AXOD/AXODE (AX4S) UPDATE HANDBOOK

*Updated
October, 2002*

Since the introduction of the Ford AXOD transaxle in model year 1986, there have been many major engineering design changes that have affected many of the parts used in the AXOD transaxle. This version of the AXOD "Update Handbook" begins with the 1986 model year and will explain each change, the parts affected by the change, and any parts interchange problems created by the change. This booklet is an updated version of the original.

Figure 1

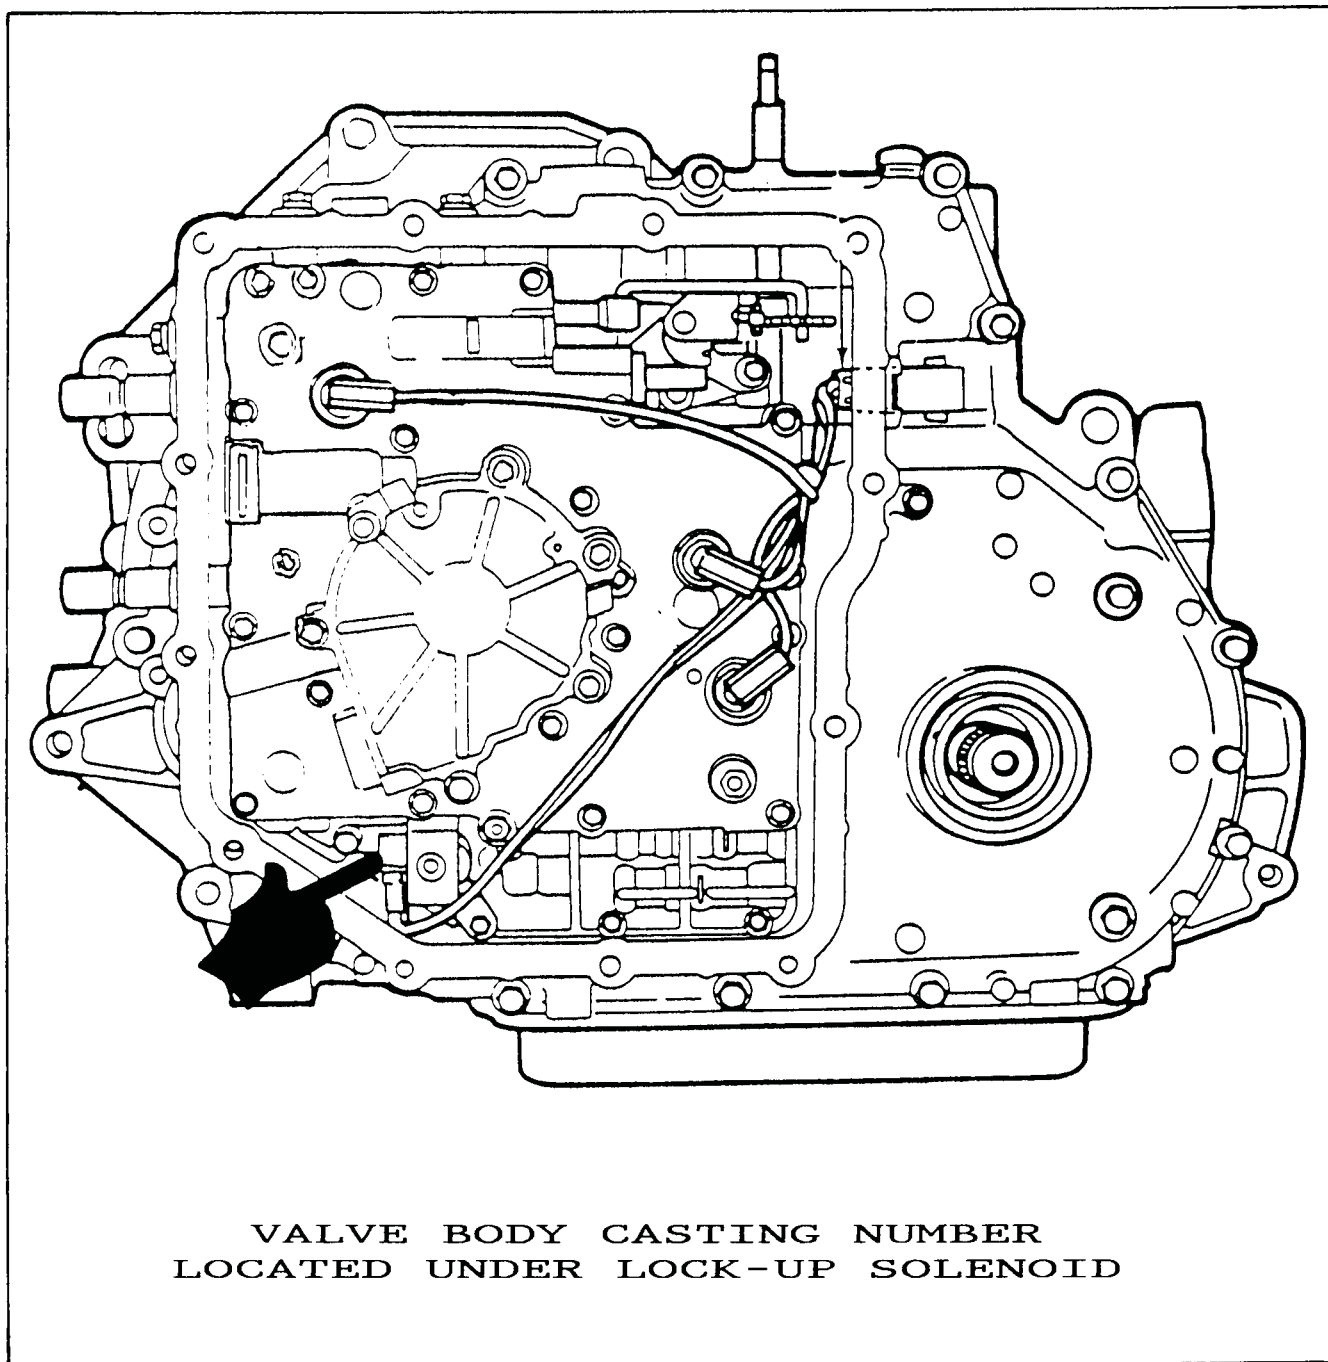
- (1) OIL PUMP CASTING - Must be identified by the casting number located on the pump as shown in Figure 1, and can be identified as follows:
 - E6SP-7B324-AA = 1986 Hydraulics.
 - E7DP-7B324-AA = 1987 Hydraulics.
 - E8DP-7B324-AA = 1988 Hydraulics.
 - E9OP-7B324-AA = 89/90 Hydraulics (10 Checkball Pump).

Figure 18

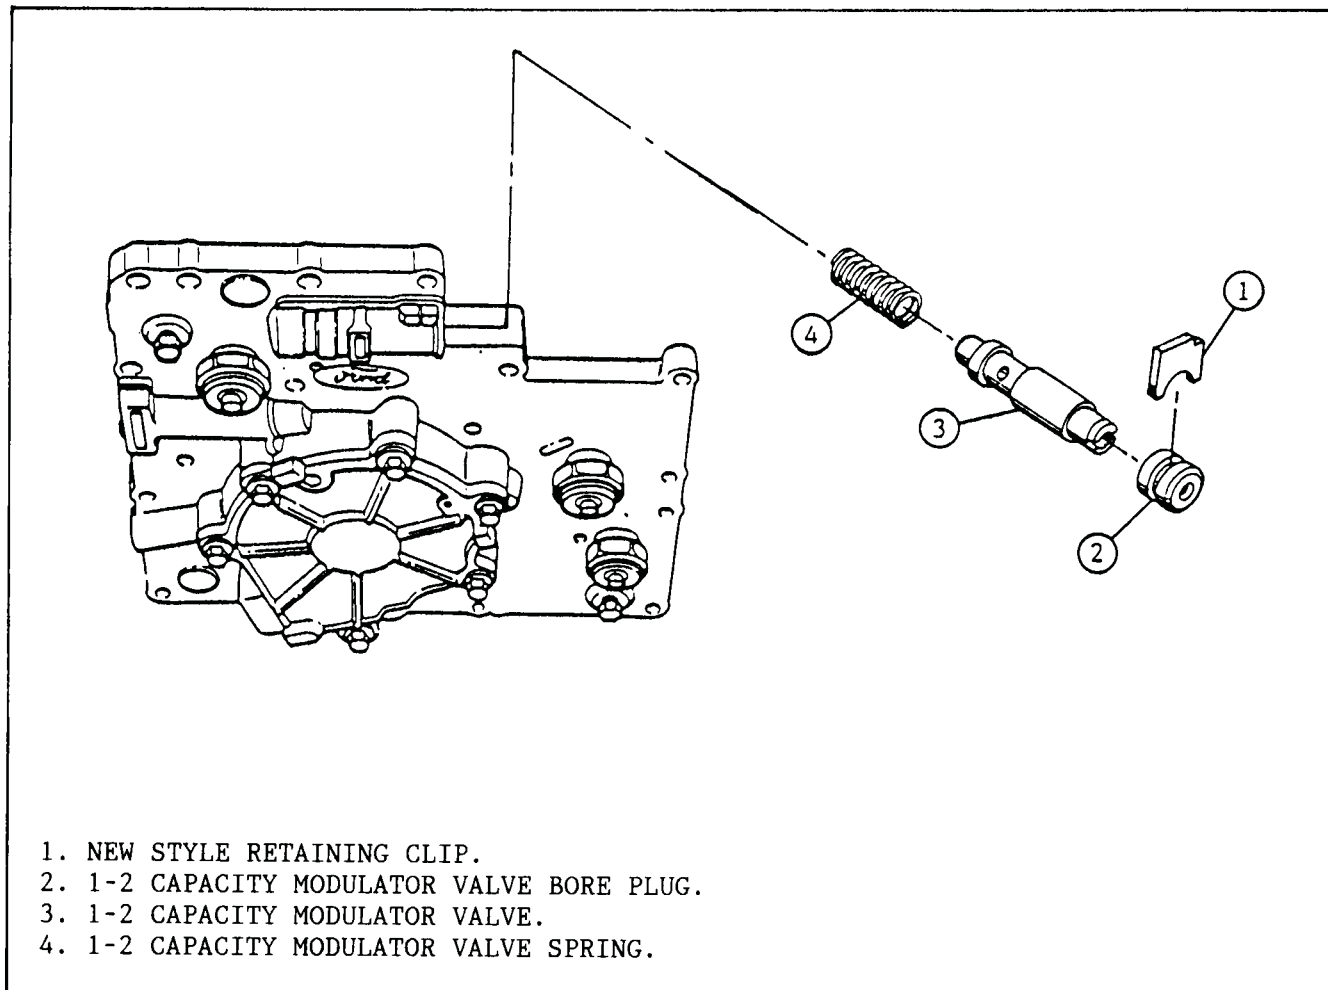
CORRECTION: FOR SOFT 1-2 SHIFT:
Replace the 1-2 capacity modulator valve spring with the Red spring manufactured by Shift Technology Products (Part #K006). The kit also comes with a new style bore plug retaining clip. Assemble into the oil pump as shown in Figure 18. This modification should be made on all AXOD'S during rebuild.

Figure 19

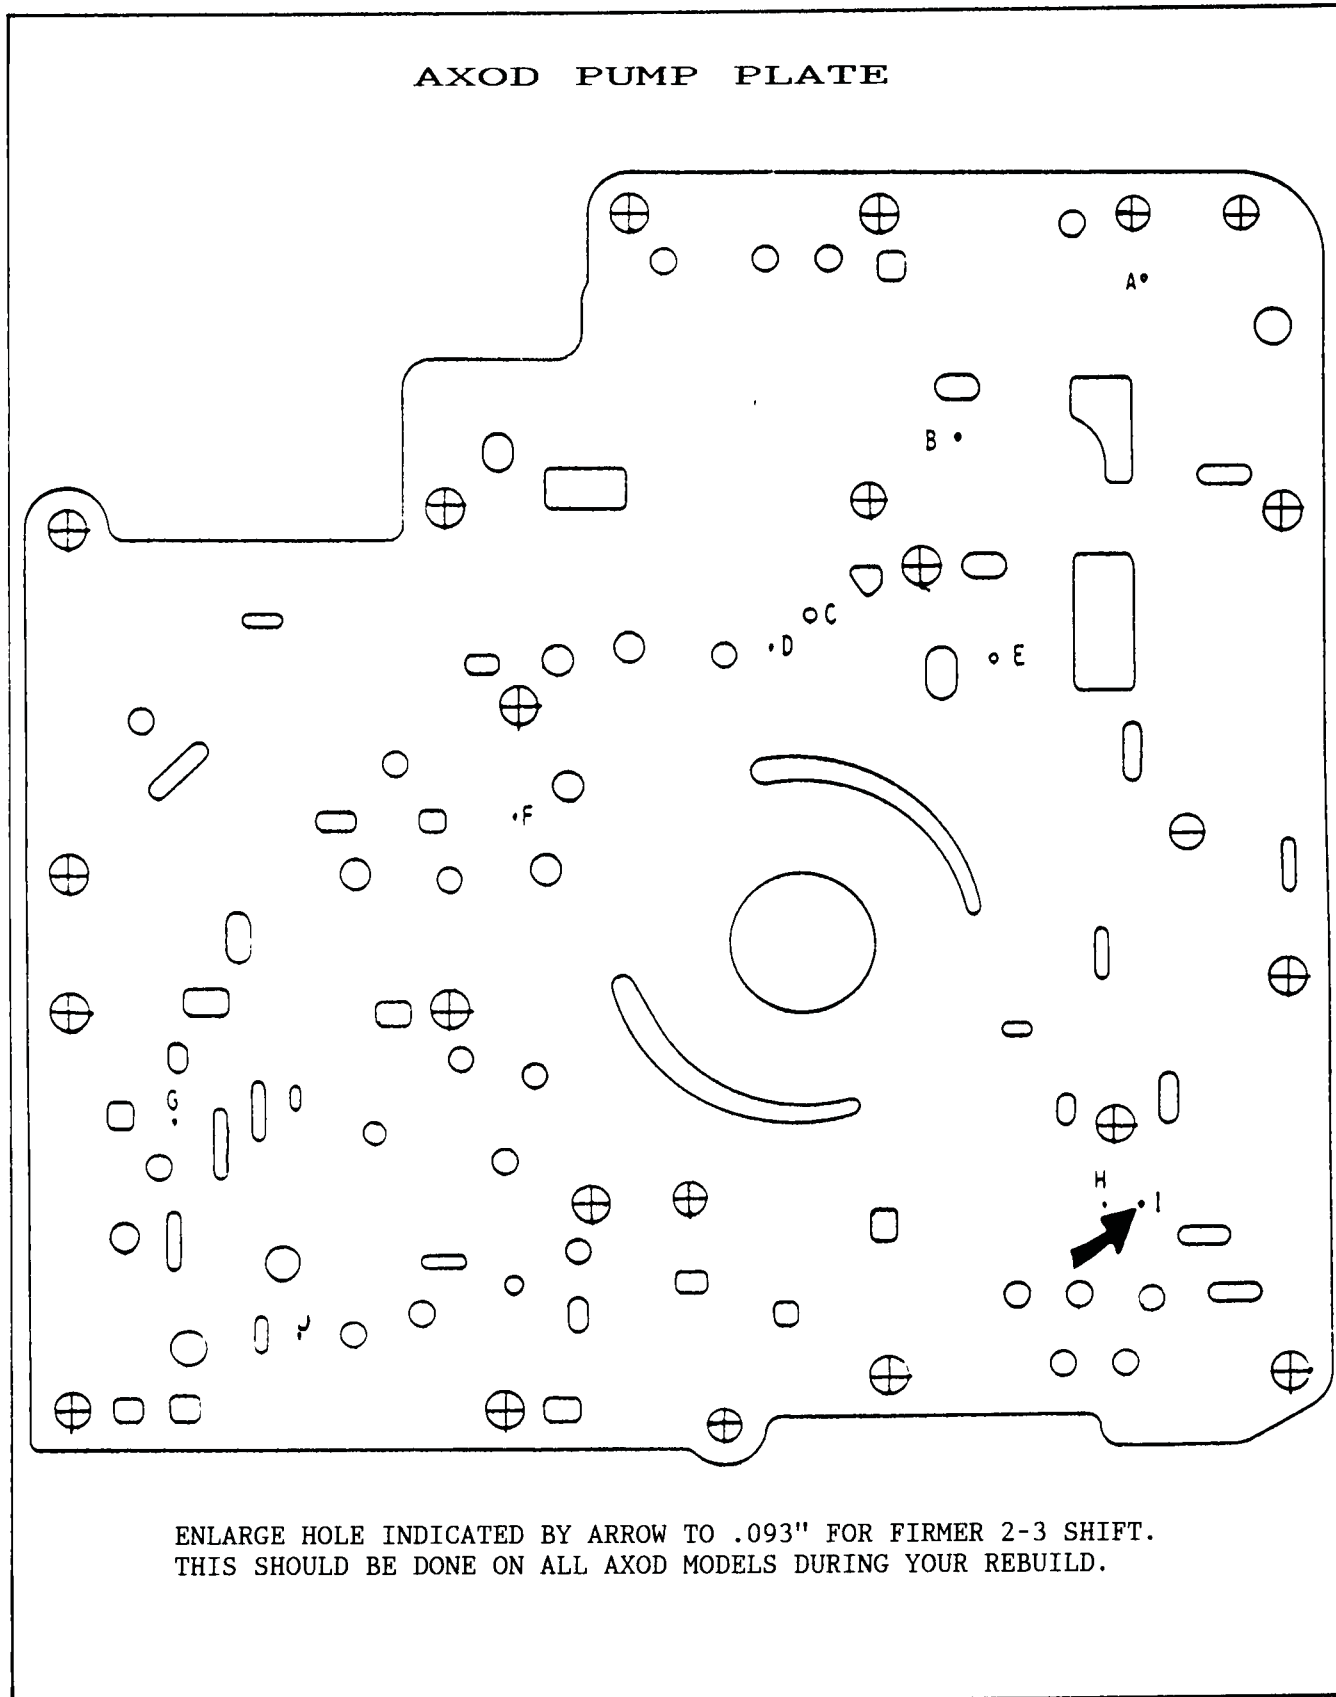
FOR SOFT 2-3 SHIFT:
Drill the direct clutch feed passage in the oil pump spacer plate, hole marked "I", out to .093" as shown in Figure 19.

Figure 27

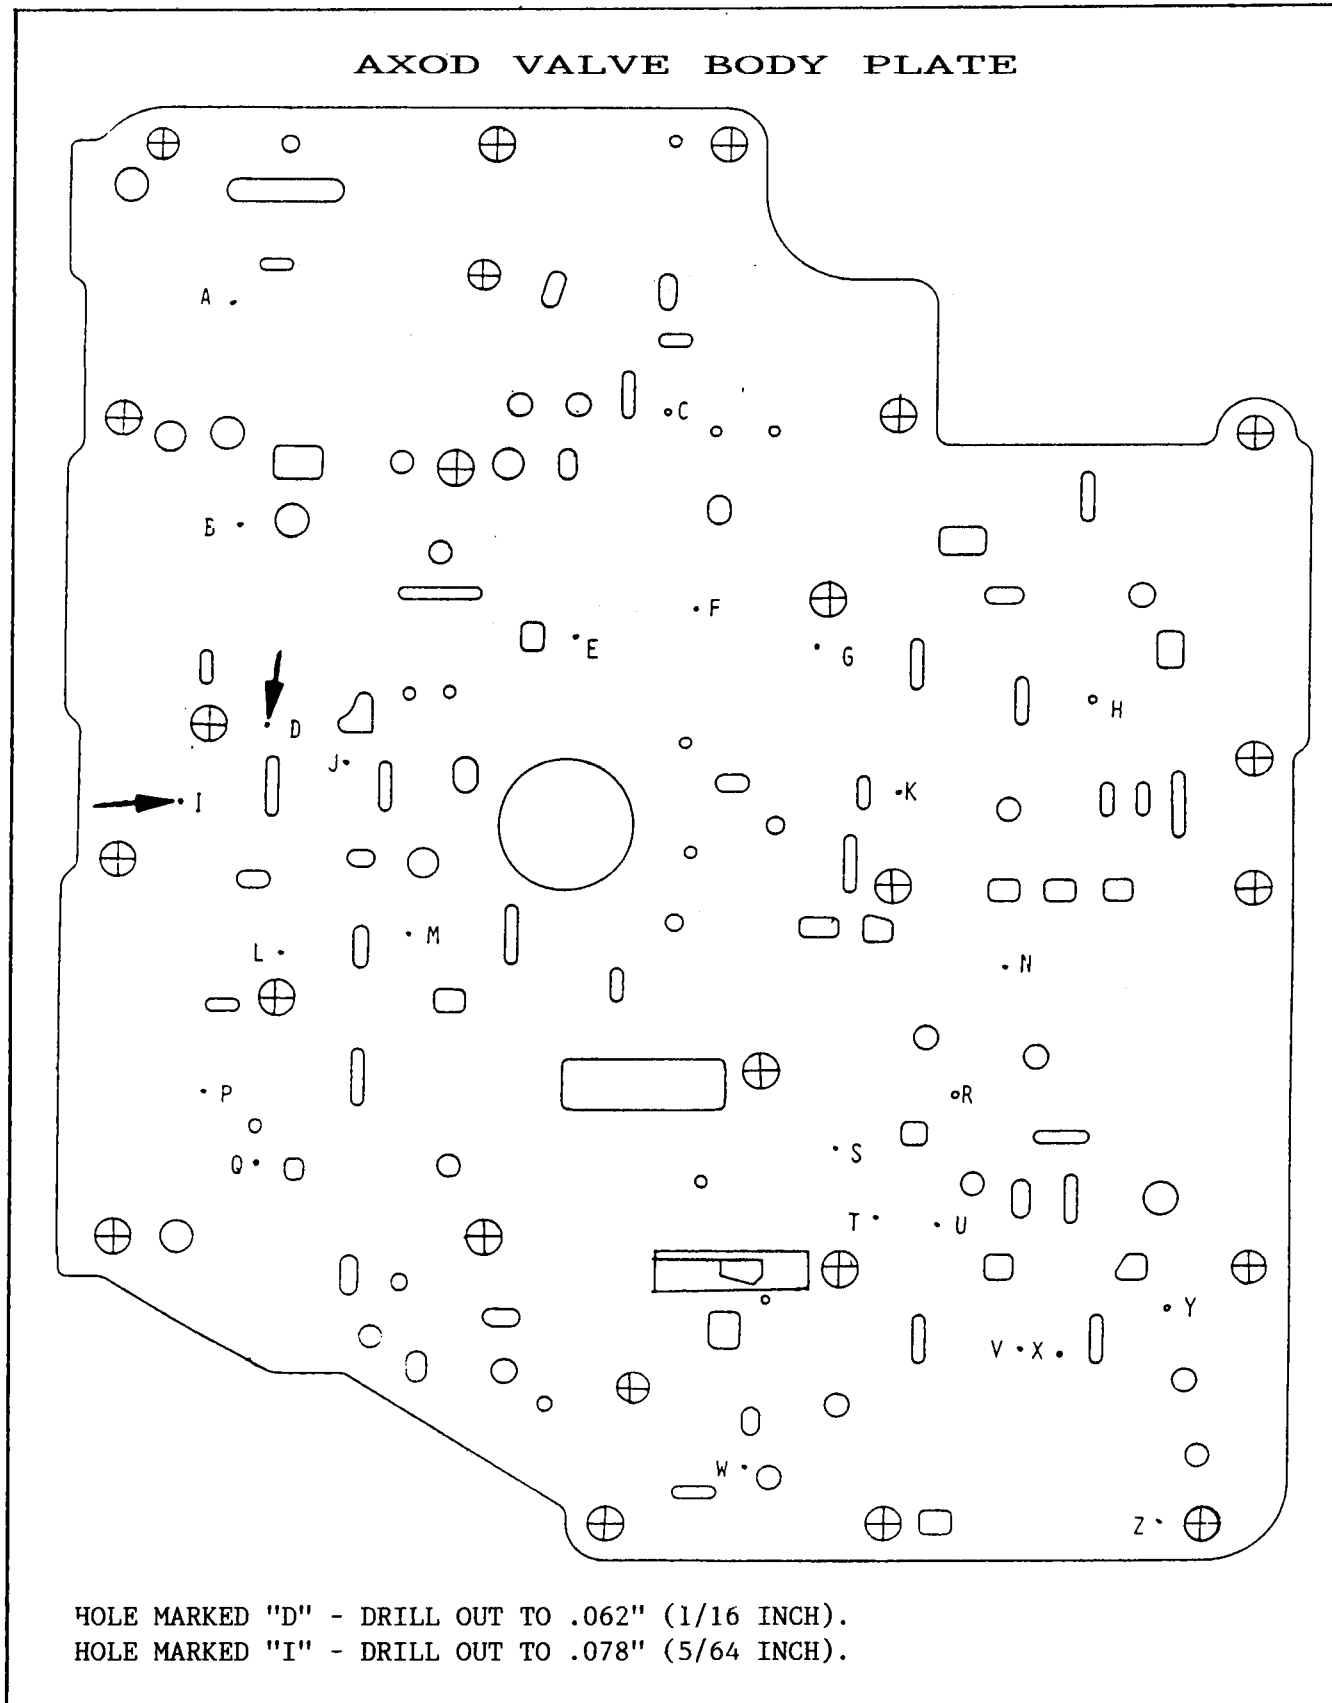
1. Drill the torque converter fill hole in the valve body spacer plate out to .062" (1/16 Inch). This is the hole marked "D" as shown in Figure 27.
Drill the rear lube orifice in the valve body spacer plate out to .078" (5/64 Inch). This is the hole marked "I" as shown in Figure 27.

Figure 32

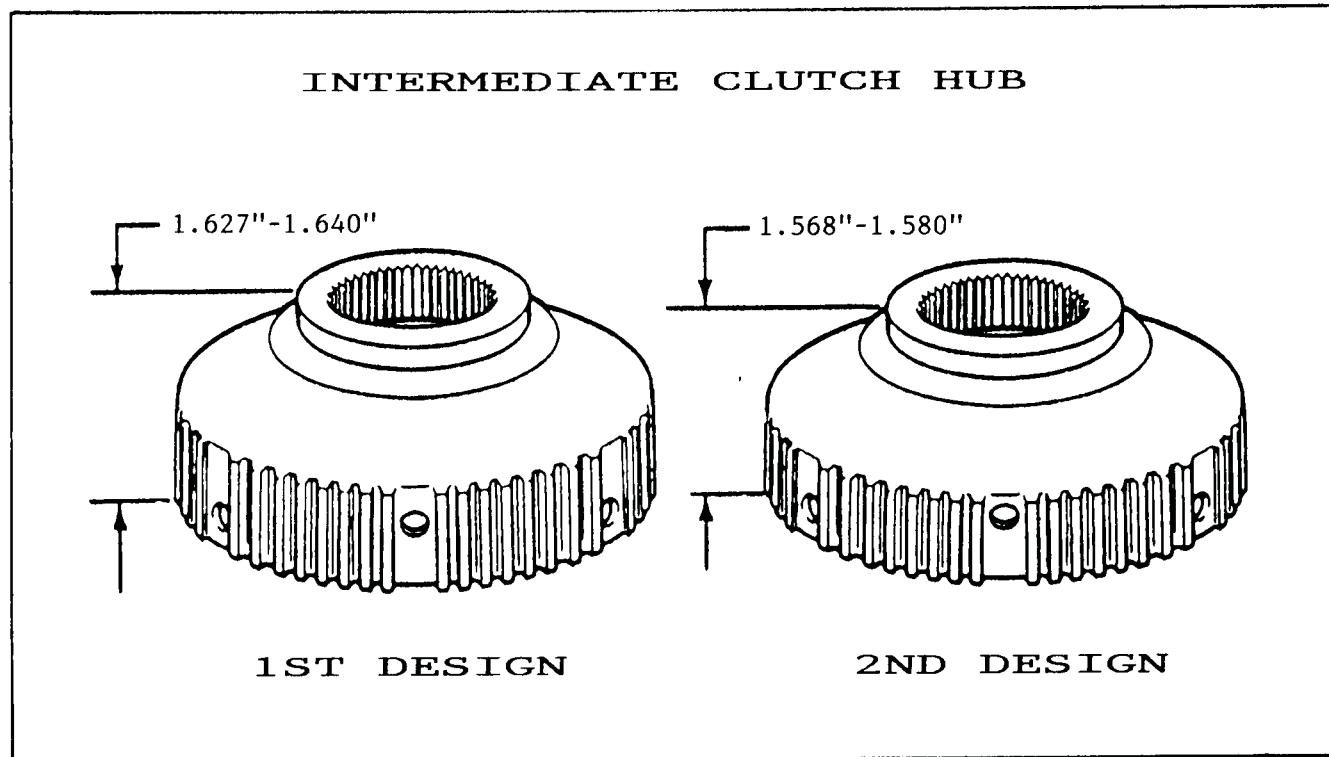
- (2) **INTERMEDIATE CLUTCH HUB** - Overall height was made shorter by approximately .060" with no identifying marks. The hub **MUST** be measured with a dial caliper or depth gage.
The 1st design hub will measure 1.627"-1.640", and the 2nd design hub will measure 1.568"-1.580" as shown in Figure 32.

Figure 35

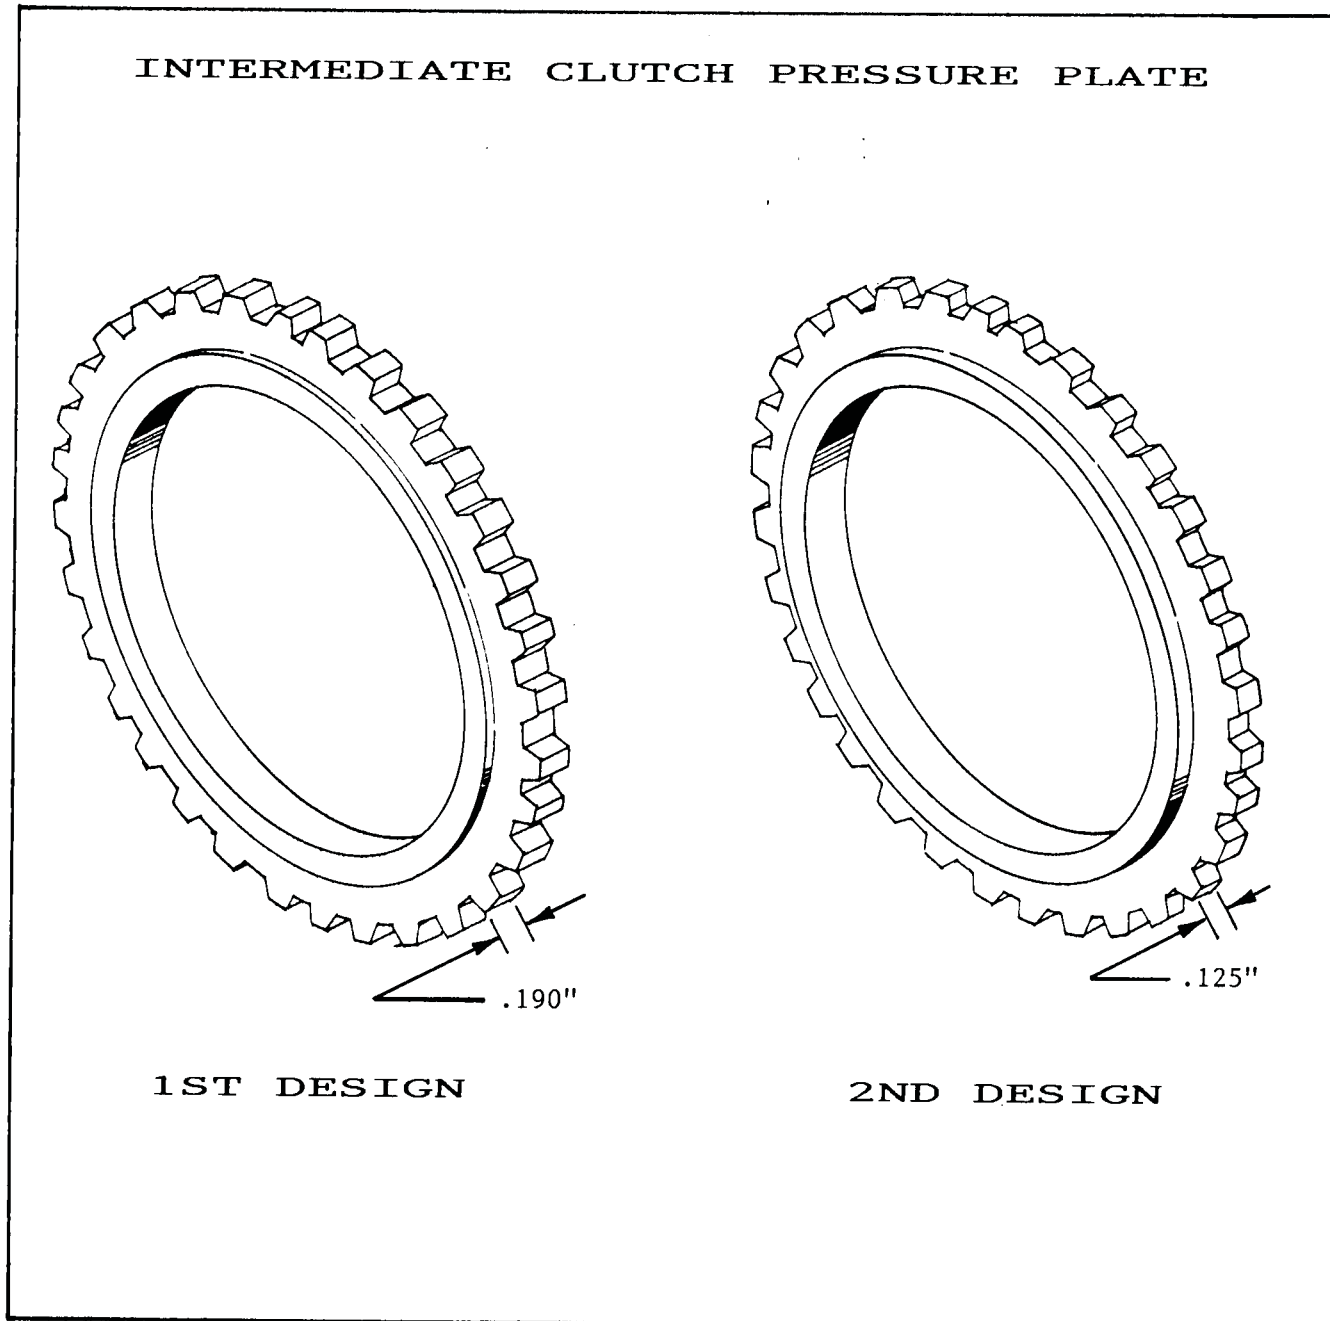
- (4) **INTERMEDIATE CLUTCH PRESSURE PLATE** - Thickness was reduced by .065" to help accomodate the added wave plate on 3.8L models, or the added spacer plate on 3.0L models.
The 1st design pressure plate is .190" thick, and the 2nd design pressure plate is .125" thick as shown in Figure 35.
